ECS Noise Detection Alarms due to Periodic 24-VDC Low Insulation

SL2012-561/KBH
April 2012

MAN Diesel & Turbo offers free rectification kits for chafed wires in ME ECS junction boxes causing ECS noise detection alarms due to periodic 24-VDC low insulation.

A: Chafed wires in MTBFP
B: Correctly installed wires in MTBEV

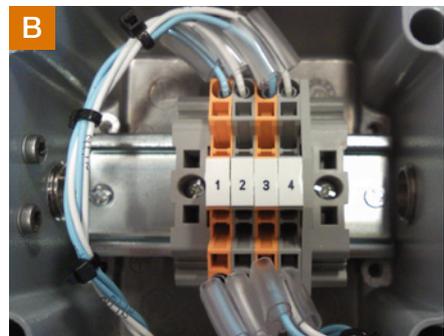
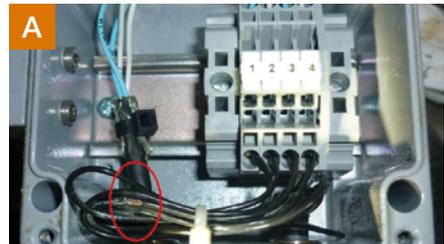
We have recently received a number of reports of ECS noise detection alarms caused by periodic low insulation. In many cases, the root cause has been found to be chafing of the wiring inside the locally installed ME ECS junction boxes. These alarms may arise when the engine is running and the wiring vibrates against the interior of the junction boxes.

In order to assist owners and operators of our ME/ME-C and ME-B engines with rectifying or preventing these incidents, we have decided to offer free-of-charge kits for rectification of each junction box affected.

These kits are tailored to fit each junction box type, and can be ordered free of charge from MAN Diesel & Turbo until 6 months from the date of this Service Letter.

Wiring in contact with TB-LOP interior

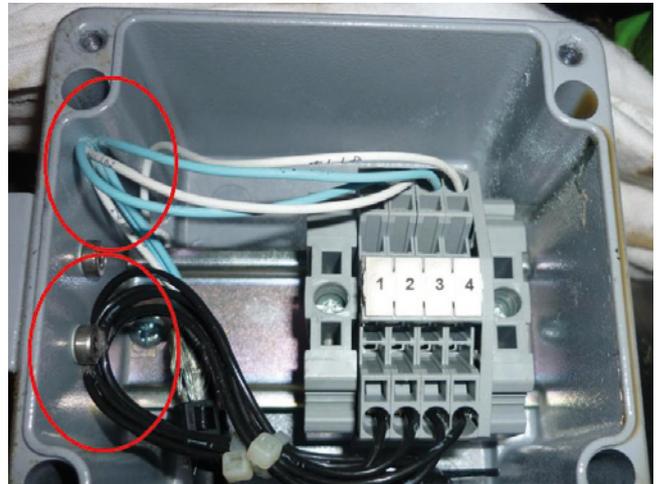
In rare cases, incidents with chafed wires have also been reported from the following junction boxes:

It is also recommended to visually inspect and rectify the wiring inside these junction boxes, so as to ensure that no wires are in direct contact with the junction box interior or other ground-leading material.

Rectification can be done easily with wire straps only.
